# UNITED STATES PATENT AND TRADEMARK OFFICE

10/765,470

# Office Action Summary

## **DETAILED ACTION**

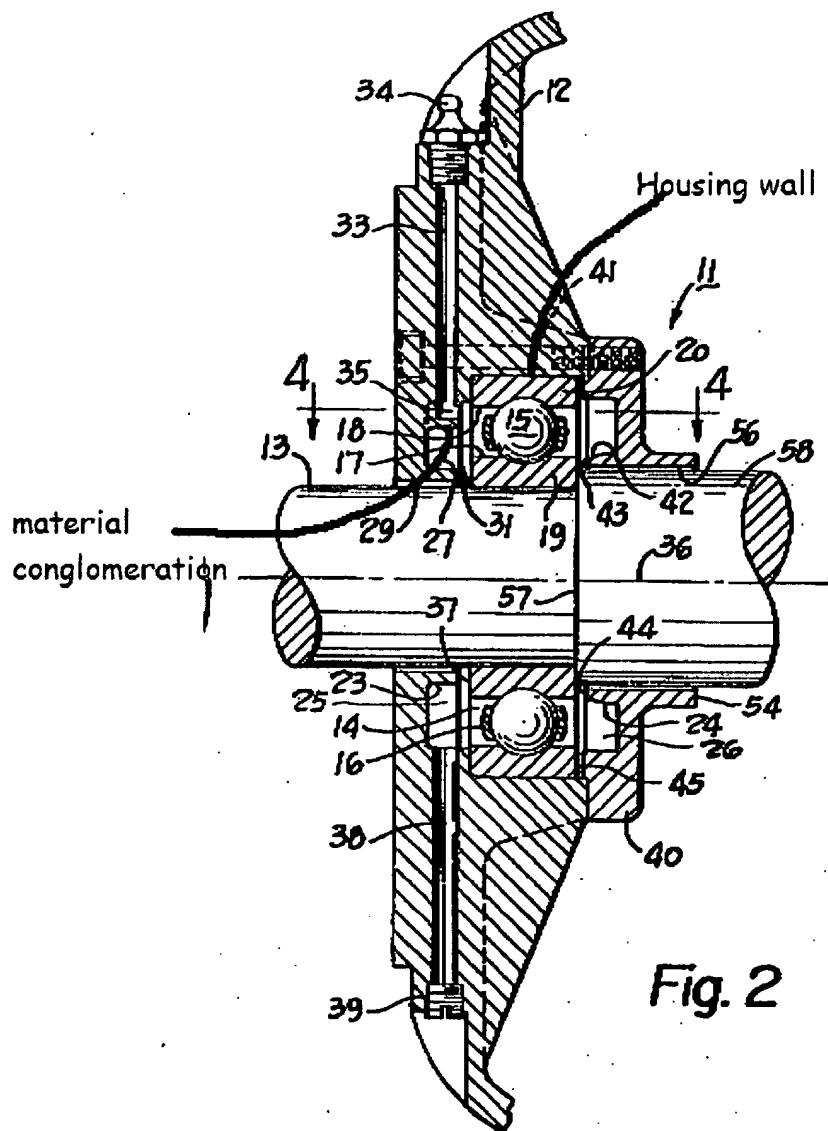
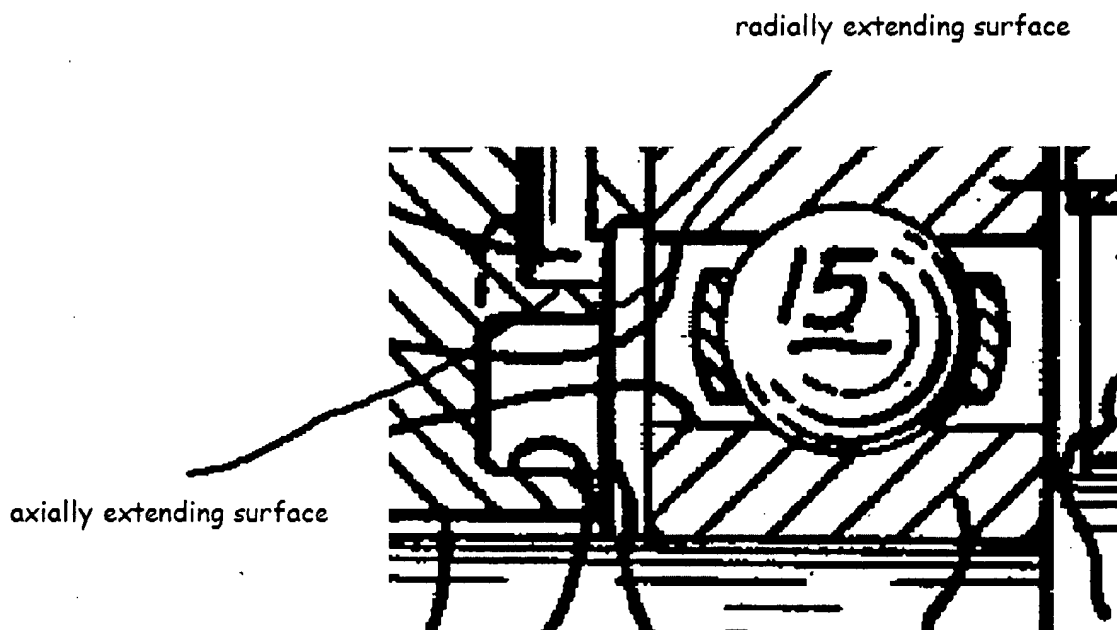
Simmons discloses a grease lubricated bearing housing (12) possessing an interior and having a housing wall (see figure below) arranged to form a bearing seat for an outer race ring of a bearing, and having on each axial side of the bearing seat a space (25 and 26) limited by an axially extending wall portion and a radial gable wall, the bearing housing having an opening (29) for receiving a shaft supported in the bearing, the wall of the bearing housing being provided with a through bore (35) adapted to receive a grease nipple and opening to the interior of the bearing housing in at least one of the two spaces axially outside the bearing seat, an interior of the bearing housing wall being provided with a material conglomeration (see fig below) positioned in relative to the through bore opening into the interior of the bearing housing so that the material conglomeration urges grease introduced through the through bore to move primarily towards the bearing seat to inhibit grease from primarily filling out the space into which the through bore opens.

Regarding claim 2, the through bore has an orifice extending through at least part of the material conglomeration, projecting towards the bearing seat.

Regarding claim 3, the material conglomeration possesses a stepped portion comprised of an axially extending surface and an adjoining radially extending surface,

the radially extending surface facing the bearing seat, and the through bore extending through the material conglomeration and opening in the axially extending surface, with the radially extending surface of the stepped portion in combination with the axially extending surface forming a shield urging grease introduced through the through bore to move primarily towards the bearing seat while also preventing grease from primarily filling out the space into which the through bore opens.

Fig. 2

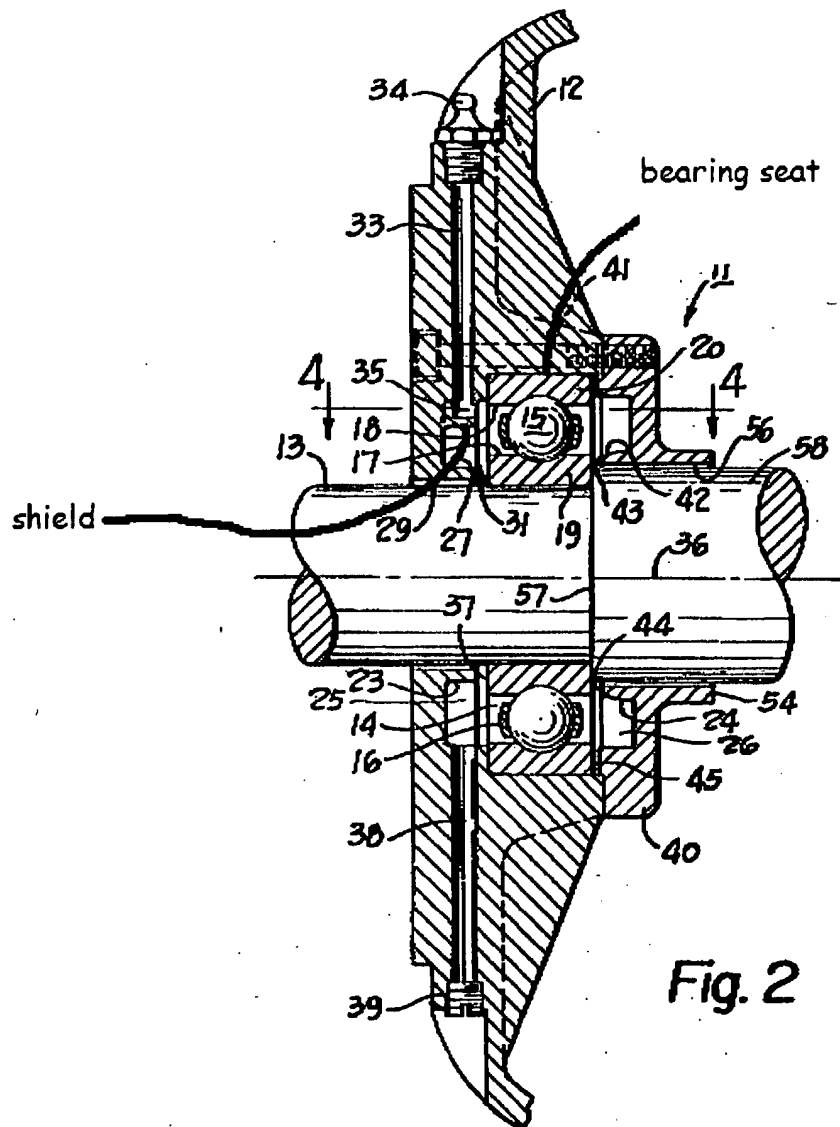
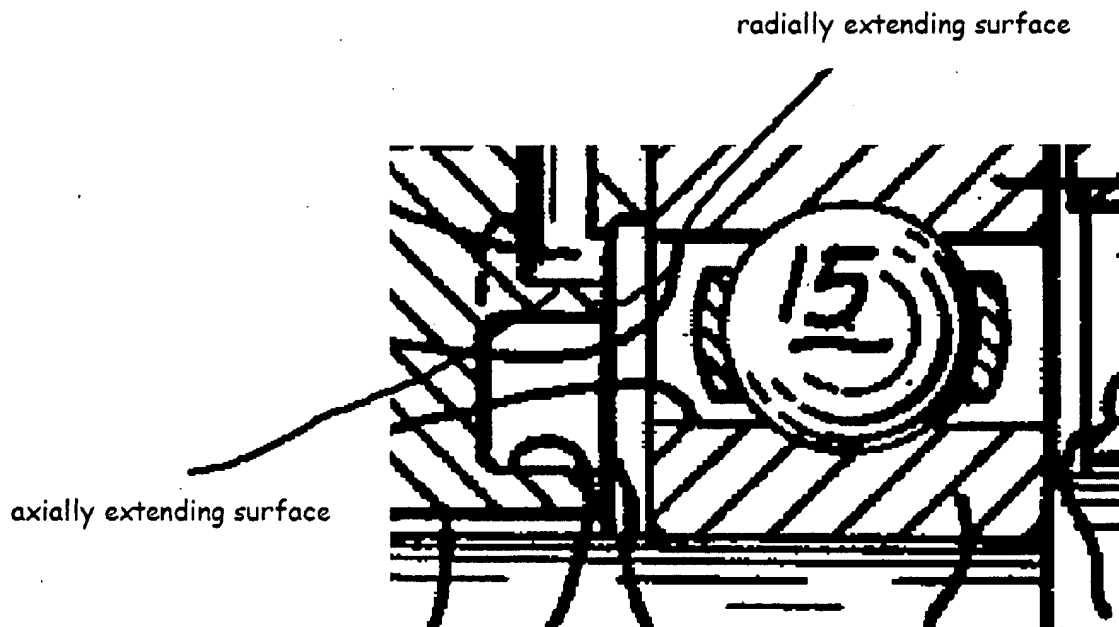
Regarding claim 13, Simmons discloses a grease lubricated bearing housing comprising two housing parts (12, 40) which together form a housing interior provided with a bearing seat in which is seated an outer race ring of a bearing, with an annular chamber (25 or 26) located on at least one axial side of the bearing seat, the space being limited by an axially extending wall portion and a radial gable wall, the bearing housing having an opening at least at one end for receiving a shaft passing at least partially through the bearing housing, a first one of the housing parts being provided with a bore (35) extending from exterior of the bearing housing and opening into the space at a position axially outside the bearing seat, the bore being adapted to receive a grease nipple (34) to permit grease to be introduced into the housing interior, the first housing part having an interior provided with a shield (see figure below) which directs grease introduced through the bore in a direction towards the bearing seat while also inhibiting grease from primarily filling out the space into which the bore opens.

Regarding claim 14, the shield is integrally formed in one piece with the first housing part (12) and the bore extends through part of the shield.

Regarding claim 15, the shield is a material conglomeration integrally formed in the first housing part and extending inwardly from the interior of the first bearing

Regarding claim 16, the shield possesses a stepped configuration comprised of an axially extending surface and an adjoining radially extending surface, the radially extending surface facing the bearing seat and the bore extending through the shield and opening in the axially extending surface.
